**GREATER NEW HAVEN WATER POLLUTION CONTROL AUTHORITY
CWF 2017-01 CAPACITY UPGRADES AT EAST STREET PUMP STATION
FOR CSO REDUCTION
ADDENDUM NO. 2**

SUBMITTED QUESTIONS and REQUESTS FOR INFORMATION/CLARIFICATION:

DRAWING NO.: I-107

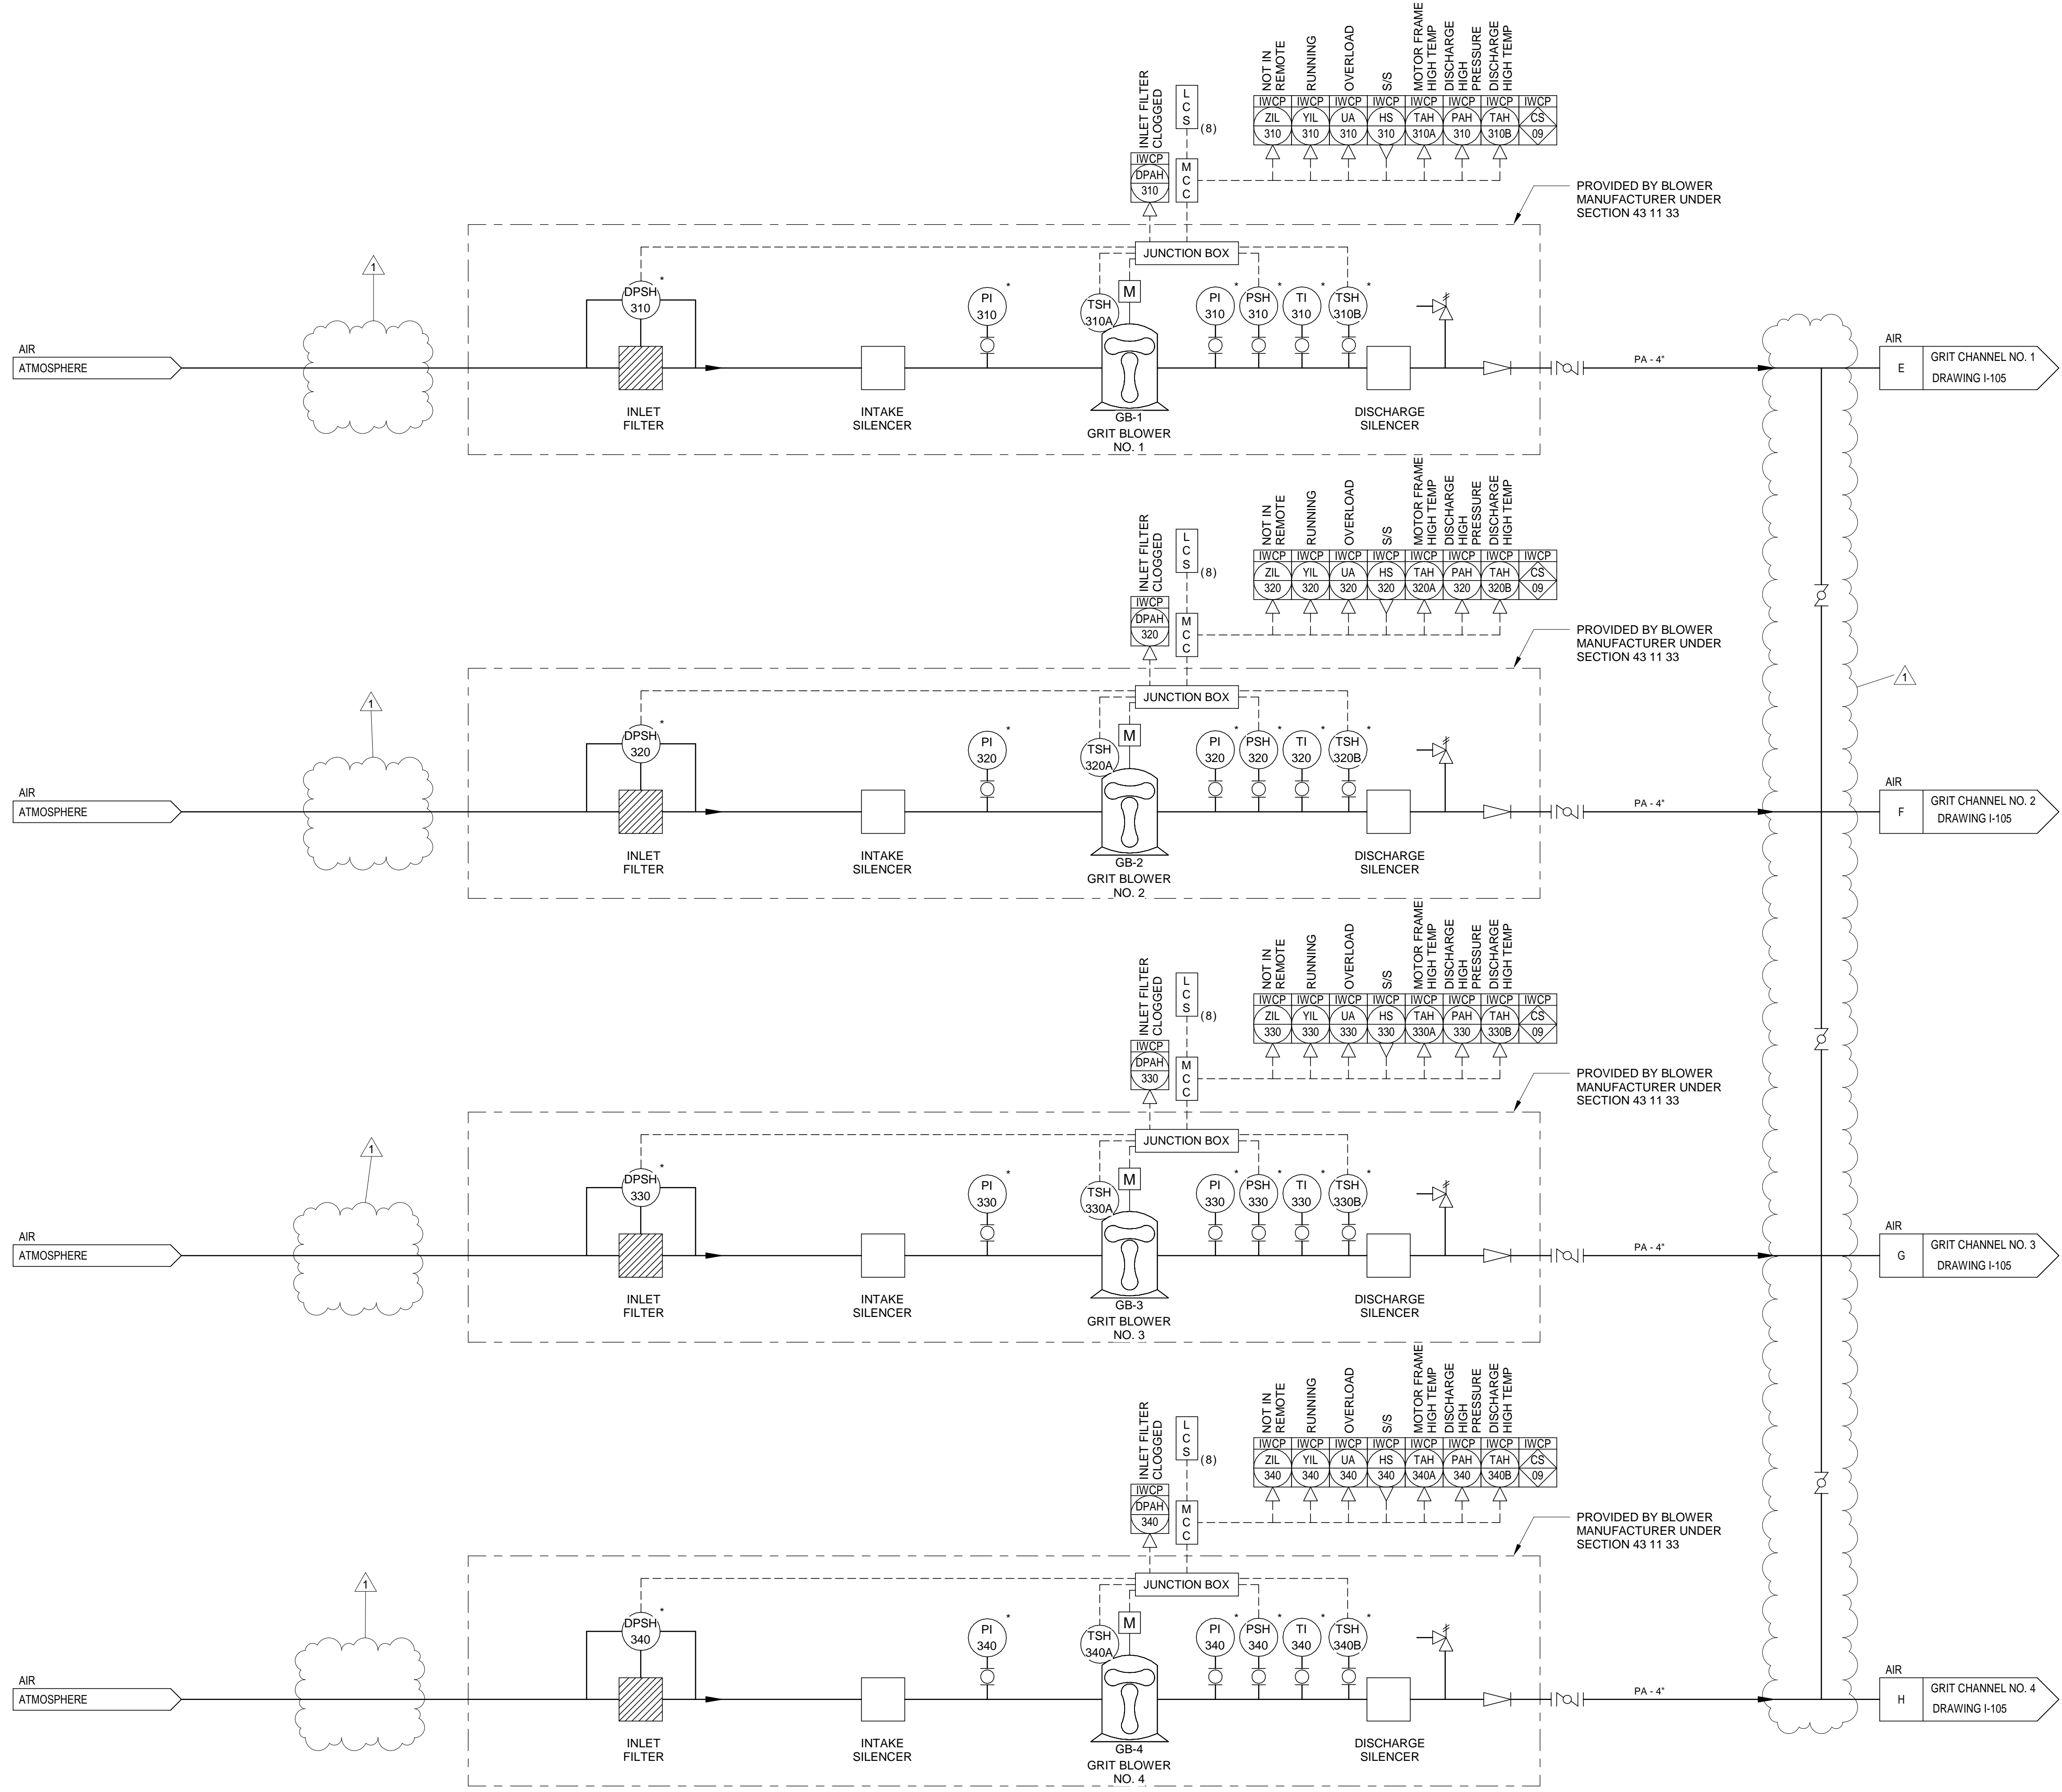
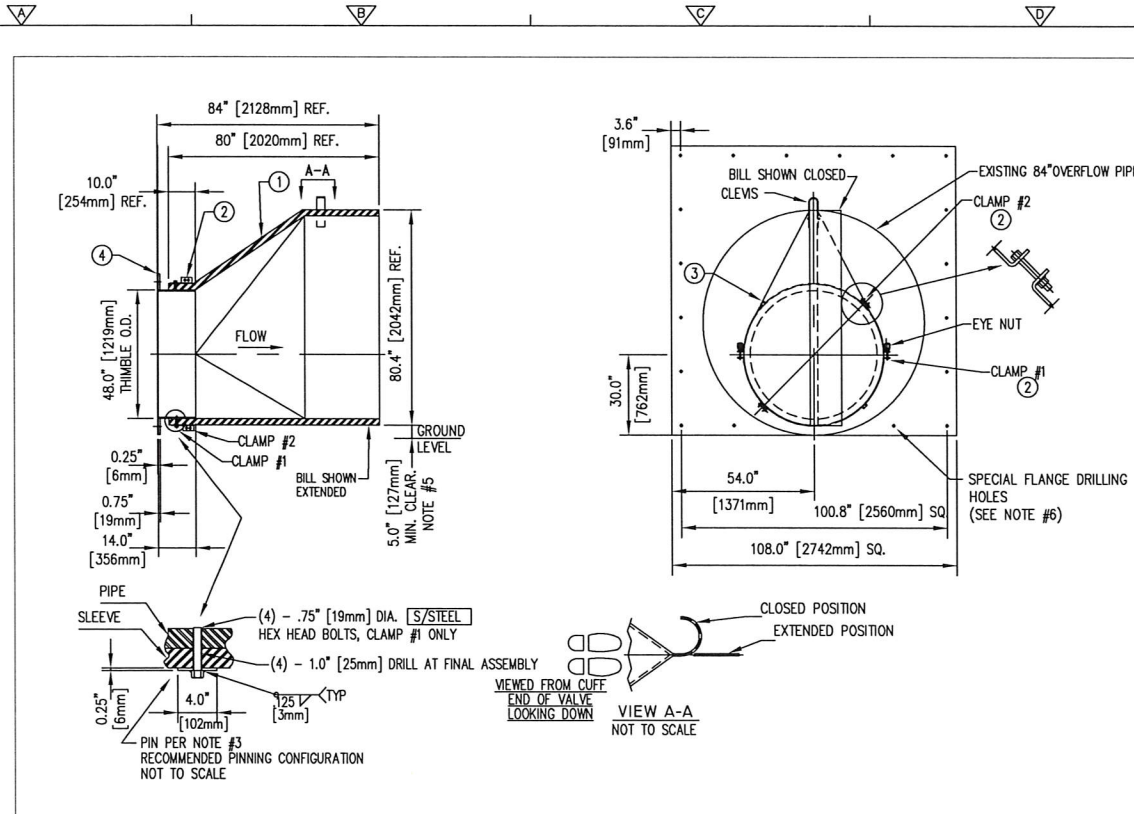
20. Question: Drawing I-107 – There are ball valves shown on the atmosphere intake for the Grit blowers. The mechanical drawings don't show any intake piping or valves. Please clarify if piping and valves are required for the atmosphere intake.

21. Question: Drawing I-105 / 107 – Shows the discharge piping to each grit collector without any common header. Drawing M-207 shows a common header with valves

off the blowers. Please clarify if the piping and valves is as shown on the Instrumentation or the Mechanical Drawings.

Response: No valves or piping beyond what is supplied with the equipment skid are required for the grit blower intake. Clarified via this Addendum.

Response: The mechanical drawings reflect the correct layout. Sheet I-107 revised and included with this Addendum.

1993 TIDEFLEX FLANGED CHECK VALVE INSTALLATION
NOT TO SCALE - FOR REFERENCE ONLY

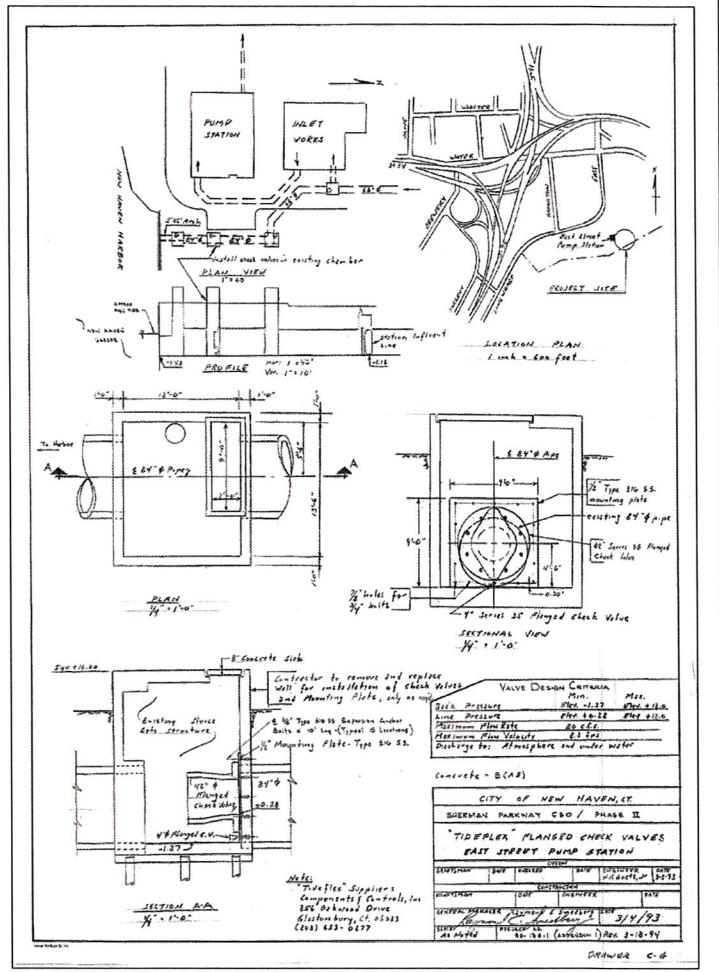
34. Question: Drawing M-701 details the work for the in-line check valve at the concrete junction chamber CSO-021. In all of the notes it does not indicate that there is an existing check valve to be removed however C-102 indicates remove and replace. Please confirm if there is an existing inline check valve that needs to be demolished and if so, please provide information of what is existing.

Response: The existing check valve is a Tideflex Series TF-1 valve, mounted to the chamber wall. A drawing showing the installation has been attached to this Addendum for reference. Detail on Drawing M-701 has been modified to note that the existing check valve shall be demolished subsequent to installation of the new valve.
